# UNITED STATES PATENT AND TRADEMARK OFFICE

09/677,870

## Office Action Summary

## **DETAILED ACTION**

**FIG. 19A**

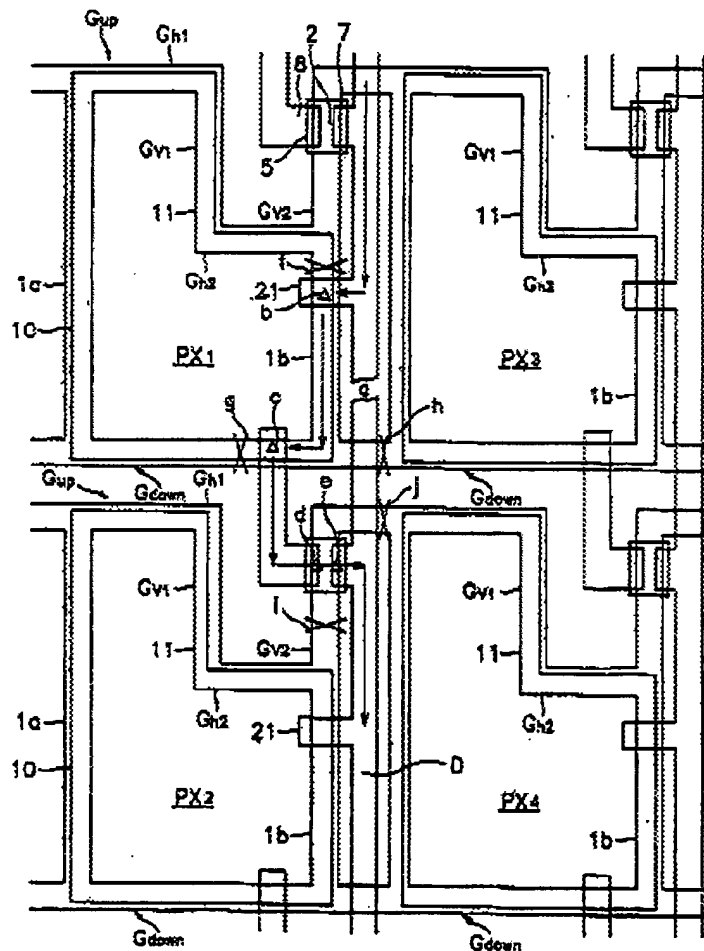
Song teaches 1) the use of a redundant pattern that is integrated with the gate line in Figure 19A ( $G_{up}$  and  $G_{down}$  or 1a and 1b) as a redundancy electrode for electrically connecting the gate line to the broken data line (col. 17, lines 4-67, especially col. 17, lines 47-54) to effect repairs.

Song is evidence that ordinary workers in the art of liquid crystals would find the reason, suggestion, or motivation to form the gate dummy pattern in such a manner as

to serve as a redundancy electrode for electrically connecting the gate line to the broken data line to effect repairs.

Therefore, it would have been obvious to one having ordinary skill in the art of liquid crystals at the time the invention was made to modify the LCD of Kim with the redundancy electrodes for electrically connecting the gate line to the broken data line per Song.

**FIG. 13**

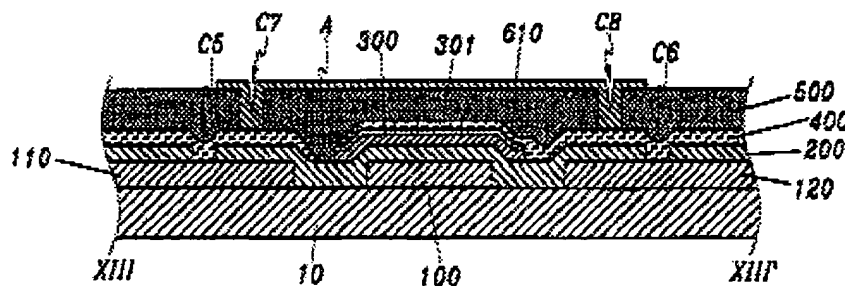
Kim teaches in Figure 13 wherein when the data line is broken, the use of forming holes and connections to the repair lines, 110 and 120, (Applicant's gate dummy pattern) and to a connecting pattern, 610, to repair a broken data line, 400, (col. 8, lines 1-15).

**FIG. 26**

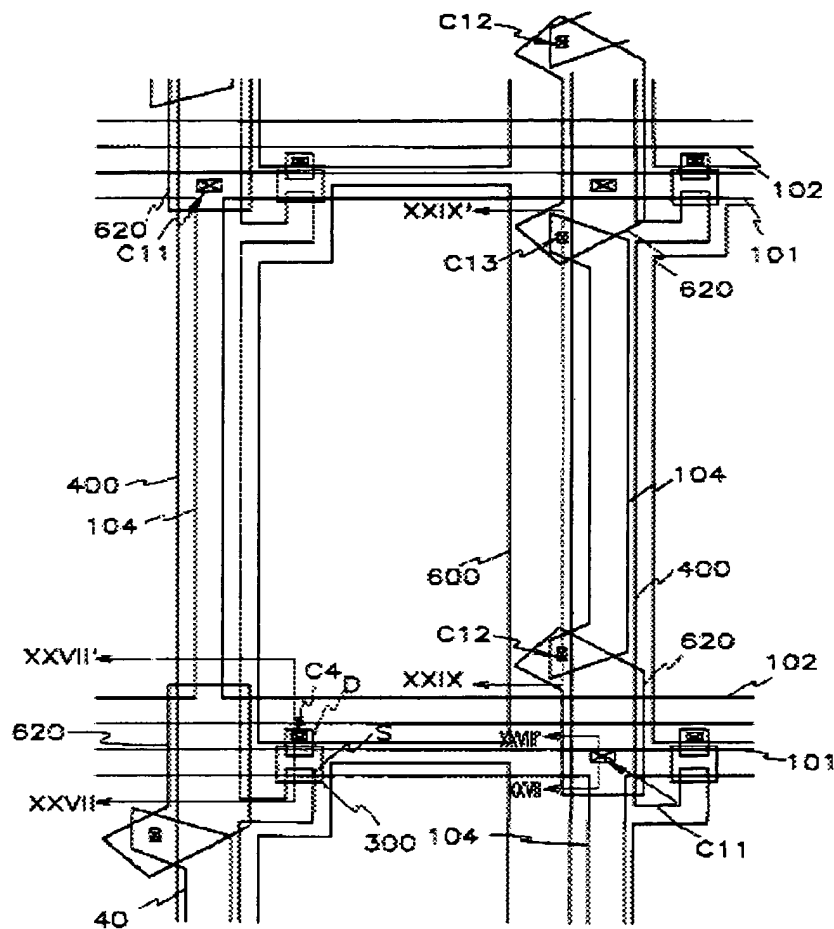
Kim teaches in Figure 26 the use of repair lines, 104, (Applicant's gate dummy pattern used as a redundancy electrode) to connect the gate line to the data line (col. 13, lines 4-17).

Kim is evidence that ordinary workers in the art of liquid crystals would find the reason, suggestion, or motivation to form holes and connect gate dummy patterns to gate lines to repair a broken data line.

Therefore, it would have been obvious to one having ordinary skill in the art of liquid crystals at the time the invention was made to modify the LCD of Kim by forming holes and connecting gate dummy patterns to gate lines to repair a broken data line.

**FIG. 19A**

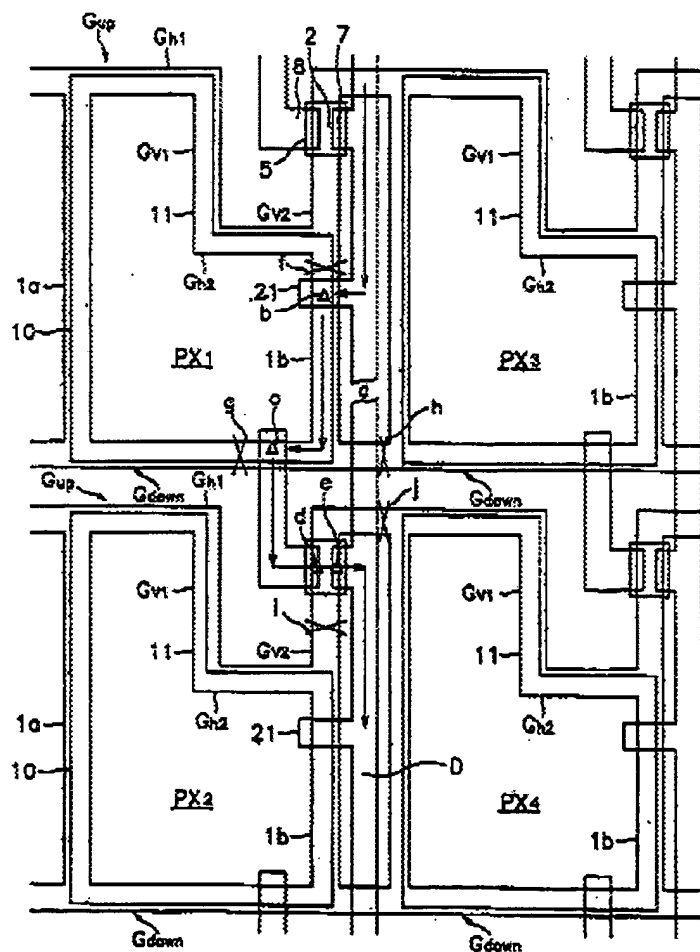
Song teaches, wherein when the data line is broken, the use of a redundant pattern in Figure 19A ( $G_{up}$  and  $G_{down}$  or 1a and 1b) as a redundancy electrode for electrically connecting the broken data line (col. 17, lines 4-67, especially col. 17, lines 47-54) to effect repairs.

Song is evidence that ordinary workers in the art of liquid crystals would find the reason, suggestion, or motivation to form the gate dummy pattern in such a manner as to serve as a redundancy electrode for electrically connecting the gate line to the broken data line to effect repairs.

Therefore, it would have been obvious to one having ordinary skill in the art of liquid crystals at the time the invention was made to modify the LCD of Kim with the redundancy electrodes for electrically connecting the gate line to the broken data line per Song.

**FIG. 18**

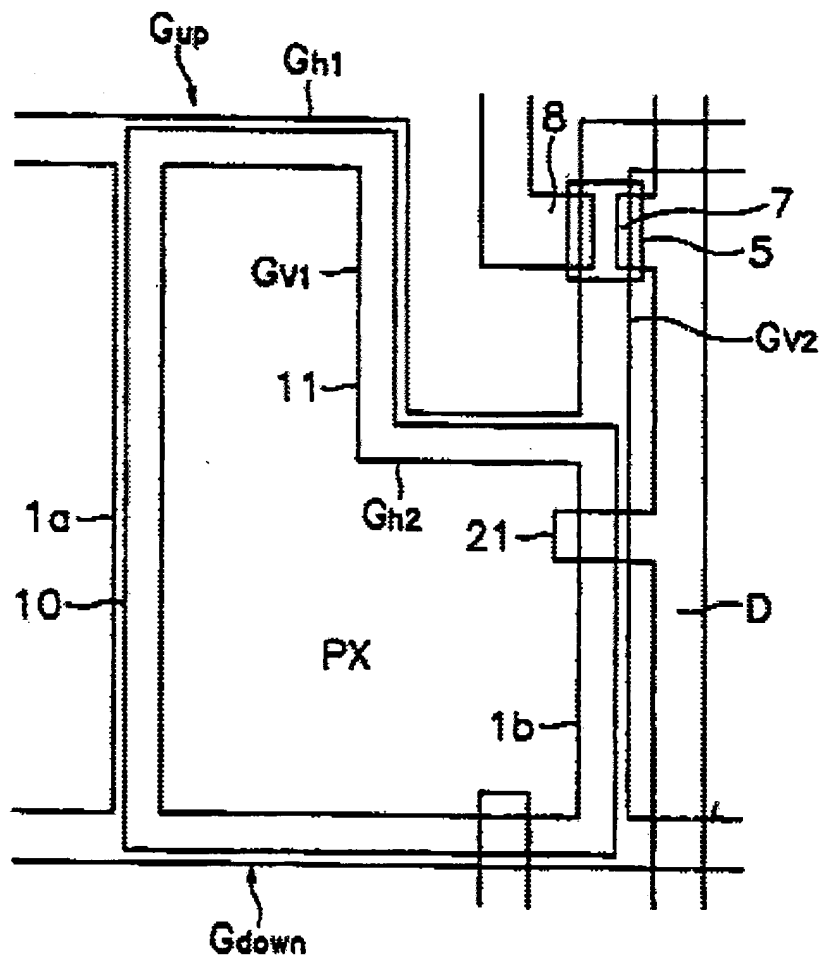
As to claims 6, 15, 22, and 24, and Song teaches in Figure 18 a thin film transistor substrate further comprising: a storage capacitor (col. 15, lines 56-64) defined by a horizontal overlapping part,  $G_{h2}$ , between the gate line and the pixel electrode, PX. Song also teaches in Figure 18 an analogous overlapping portion, 21, of the data line, D, to permit a repair. Also, any two conductors separated by an insulator result in a capacitor as a matter of physics. Therefore the overlap region between the pixel electrode and the dummy pattern which are separated by an insulator necessarily forms a capacitor.

As to claims 7 and 16, Song teaches in Figures 18 and 19A a protrusion, 21, protruded from the data line in such a manner to overlap with the intended repair site (Applicant's recess and narrowed portion of the gate dummy patterns), the structure of which would thereby shut off a light leaked between the gate dummy pattern and the gate line (col. 15, lines 42-63). Note that in considering the disclosure of a reference, it

Song is evidence that ordinary workers in the art of liquid crystals would find the reason, suggestion, or motivation to add a protrusion in the data line, formed in such a manner to overlap with the area of the recess and narrowed portion of the gate dummy patterns, to permit a repair.

Therefore, it would have been obvious to one having ordinary skill in the art of liquid crystals at the time the invention was made to modify the LCD of Kim with the protrusion of Song to permit a repair.

**Fig.2 PRIOR ART**

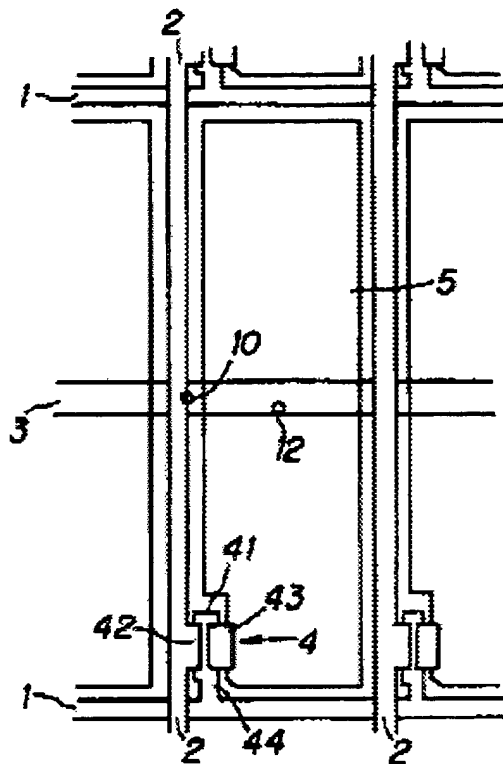
(5) Applicant's cannot find a recess in Figure 2, so the combination would not have a protrusion over the recess and would be inoperable.

(5) It is respectfully pointed that recess is on the left side of the narrow part, 44, that leads to the gate electrode, 41, in Figure 2 below:

The teaching of Irie would be more than sufficient to render the use of a recess obvious to one having ordinary skill in the art at the time the claimed invention was made, and as evidenced by the prior art, would not be confusing with respect to the need for light blocking layers (no teaching away). One skilled in the art does not forget fundamentals (like light blocking) when incorporating an added feature (like a recess/narrowed portion). Examiner cannot see any reason to believe one of ordinary skill in the art would be misled into creating an inoperable device based upon the combination of applied prior art.
